## MARINE RECREATION CENTRE

**AEE Addendum**

Kainga Ora

FROM: Sam Benson & Nick Grala DATE: 19 August 2020

FIGURE 1 - INDICATIVE LOCATION OF LOADING BAY

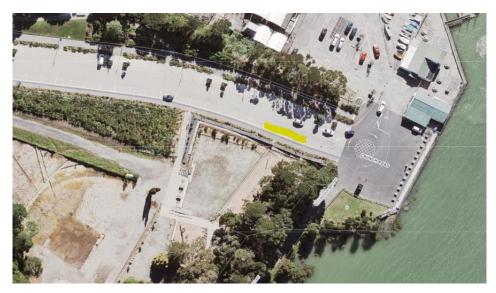
The original application relied on using a loading bay that was original planned (through a separate subdivision process) on the outside edge of roundabout at the end of Launch Road. Through this separate process, the loading bay is now no longer going to be provided at the end of this roundabout.

The applicant therefore proposes to convert the western-most three parallel car parking spaces into a P5 loading bay which will provide an adequate area for users of the MRC building to undertake drop offs and pickups (see **Figure 1** below).

As stated in Section 2.0 of this report, the proposal is now to use the westernmost 3 car parks on Launch Road as a loading bay (instead of a loading bay on the roundabout).
